Hanford Tank Waste
Treatment and Immobilization Plant

ORP Structural Peer Review Report

LAW Vitrification Building

Independent Structural Design Peer Review

Figure 5-1 Comparison of UBC-97 and IBC-2000 Spectra

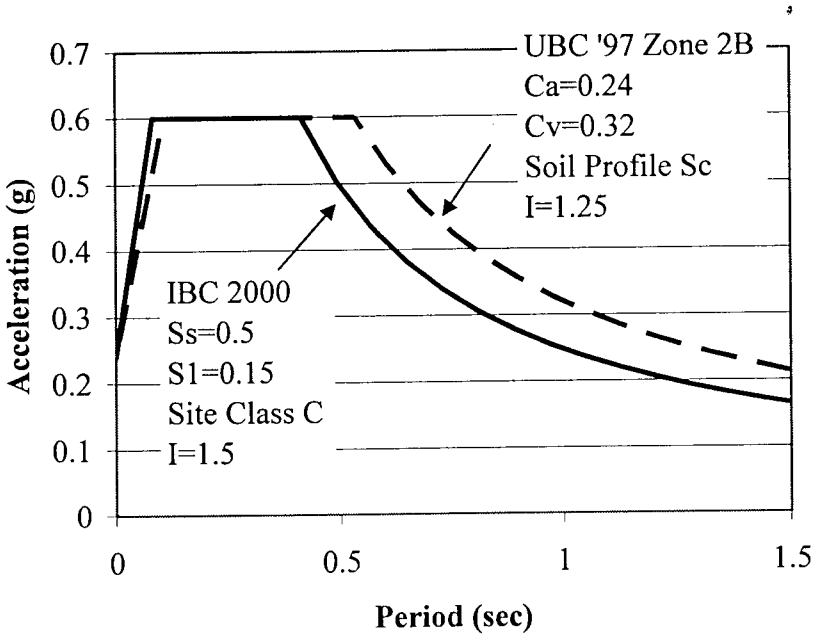
DOE-STD-1020-2002 references IBC-2000, with an importance factor, I, of 1.5 for PC-2 buildings. The IBC-2000 input spectra, with I=1.5, is compared to the UBC-97 seismic spectra used in the LAW design in Figure 5-1. These two spectra are essentially equal in the LAW fundamental period (about 0.4 sec). Thus, the seismic input used to design the LAW is consistent with DOE-STD-1020-2002.

Figure 7.3 UBC '97 Base Shear Spectra

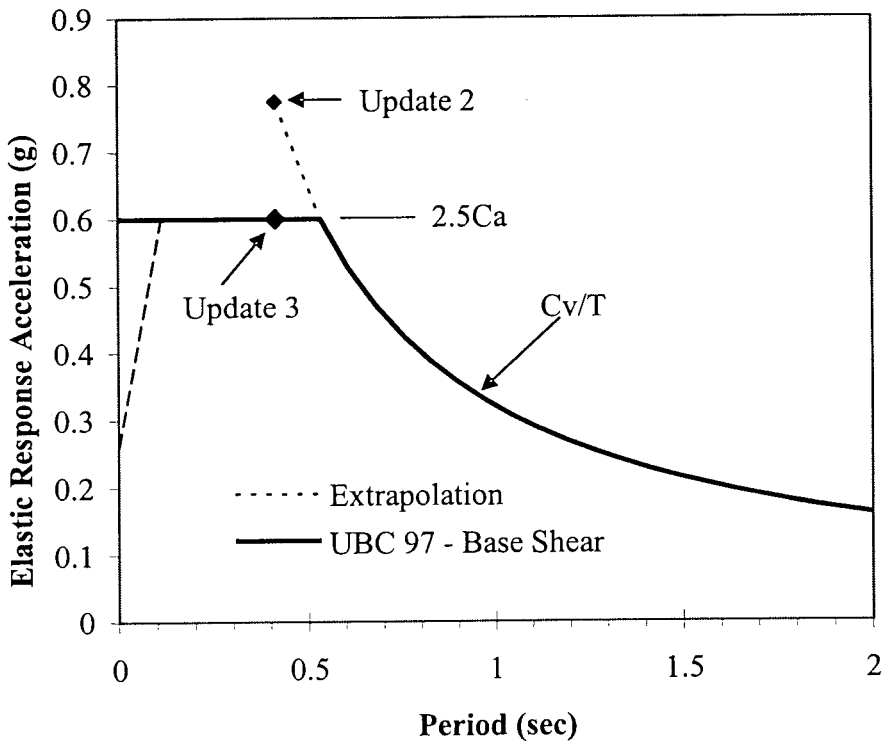
The free field spectra used to calculate the UBC '97 base shear is shown in Figure 7.3. In the long period, or constant velocity, portion of the spectra, acceleration is Cv/T, where Cv is 0.32g-sec and T is the natural period of the structure. In the short period, or constant acceleration, portion of the spectra, the acceleration is 2.5Ca, where Ca=0.24g. From the original analysis, up to and including Update 2, the LAW seismic loading was determined by extrapolating the equation for the constant velocity portion of the spectra into the constant acceleration region. Beginning in Update 3 the correct portion of the spectra was used to determine seismic loads.

Figure 7.4 Cumulative Story Shears

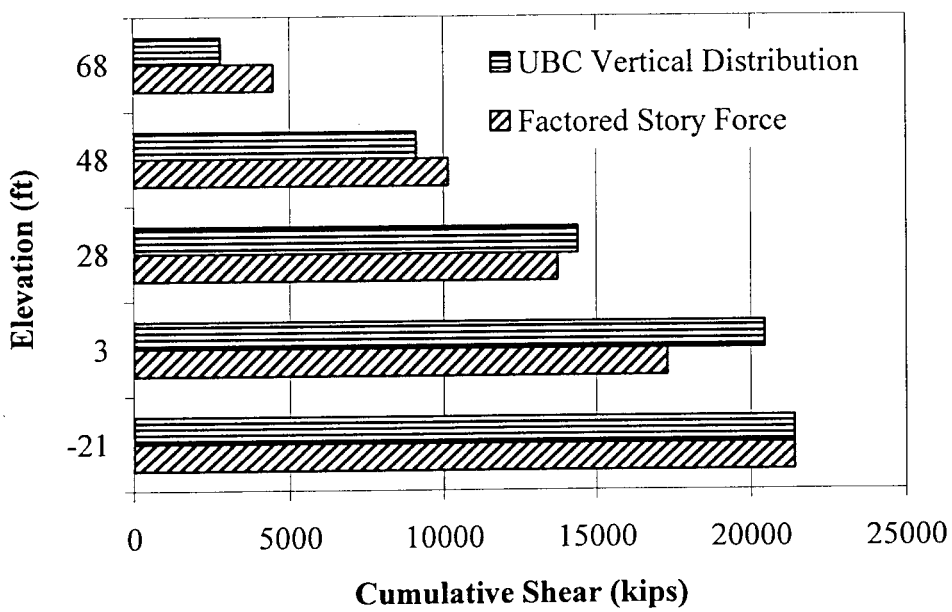
Cumulative shear is derived from Table 7.3 by summing the UBC Vertical Distribution and the Factored Story Force and is shown in Figure 7.4. Note that at elevations 28 ft and 3 ft the cumulative shear due to the factored modal story force is less than the UBC vertical distribution. The PRT recommends that BNI justify the use of the cumulative shear distribution d in their design.
